World Forum for Harmonization of Vehicle Regulations

Proposal for Supplement 2 to the 01 series of amendments to UN Regulation No. 150 (Retro-reflective devices)

Submitted by the Working Party on Lighting and Light-Signalling*

“Figure A5-VII
Example of a slow-moving vehicle plate

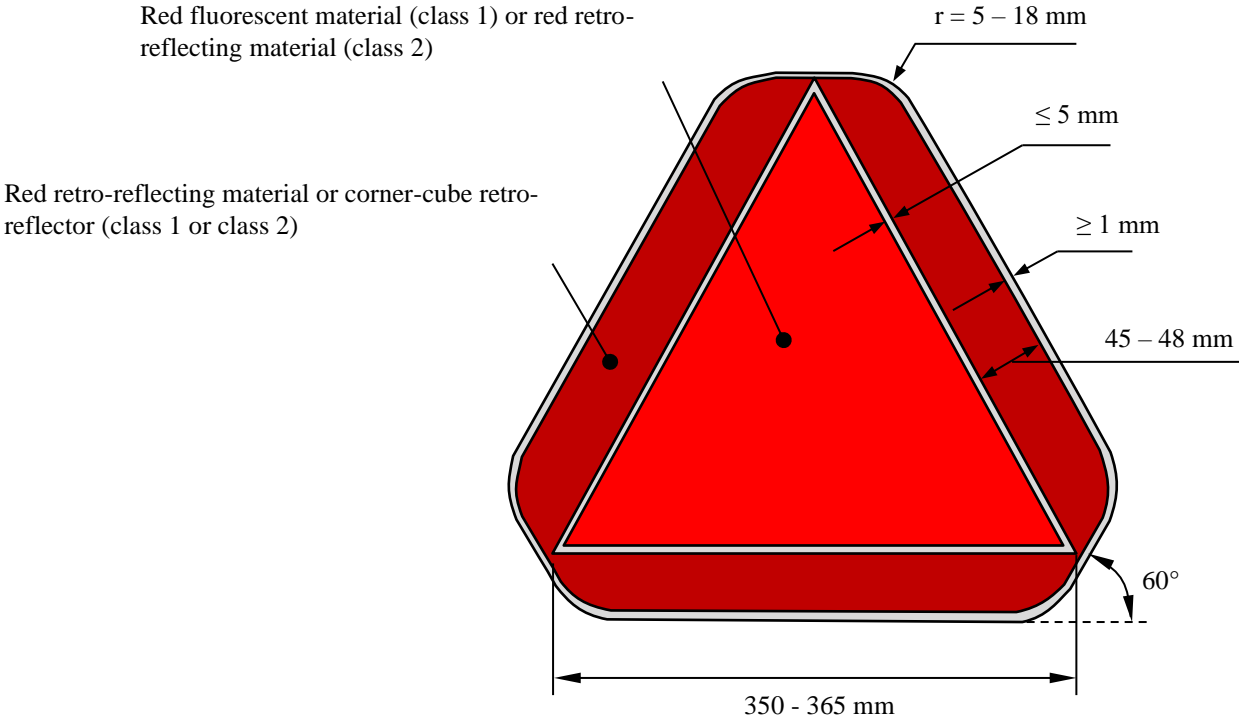
- “7.3. Dimensions
 The length of the base of the enclosed fluorescent triangle (class 1) or retro-reflective triangle (class 2) shall be: minimum 350 mm and maximum 365 mm. The minimum width of the light-emitting surface of the red retro-reflective border shall be 45 mm, the maximum width 48 mm. These features are illustrated in the example of Figure A5-VII.”

Figure A5-VI “Example of a slow-moving vehicle plate”, amend to read:
